Manual Supplement

Manual Title:	789 Calibration	Supplement Issue:	3
Part Number:	1988891	Issue Date:	11/06
Print Date:	September 2002	Page Count:	2
Revision/Date:

Change #1

Figure 2. Verifying Loop Power

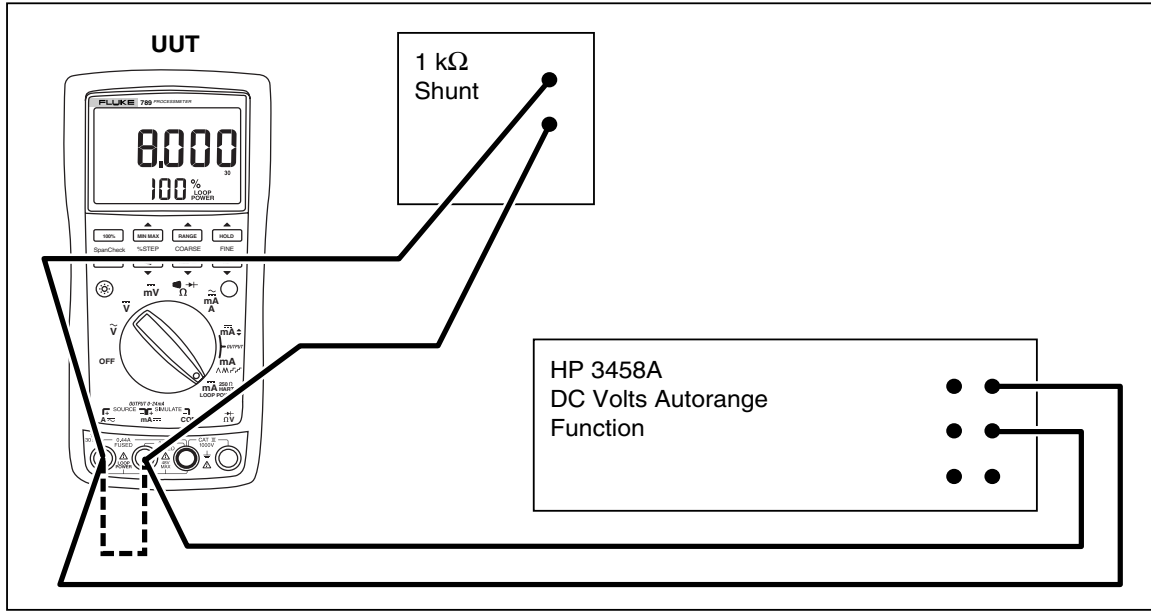
On page 12, replace the **Loop Power** procedure, and Figure 2 with the following:

1. Enable the dc volts autorange function of the HP3458A multimeter.
2. Turn the rotary knob of the UUT to **LOOP POWER**.
3. Measure the open circuit voltage of the UUT and verify it is greater than 29.8 V and less then 32 V.

4. Press the blue button on the UUT to enable the 250 Ω HART resistor.
5. Repeat step 3.
6. Disable the 250 Ω HART resistor by pressing the blue button.
7. Connect the 1-k Ω shunt across **SOURCE +** and **SOURCE -** of the UUT.

8. Measure the loaded down voltage and verify it is greater than 23.8 V and less than 32 V see Figure 2.
9. Remove the 1-k Ω shunt.
10. Disconnect the UUT from the multimeter and turn the UUT off.

11. Select the dc current function on the multimeter and set it to the 1-amp range (a 0.1 Ω shunt is used in the 1-amp range).
12. Connect the current input terminals of the multimeter to the **SOURCE +** and **SOURCE -** terminals of the UUT.

13. Turn the rotary knob of the UUT to **LOOP POWER**.
14. Verify the short circuit current is greater than 25 mA and less than 35 mA.
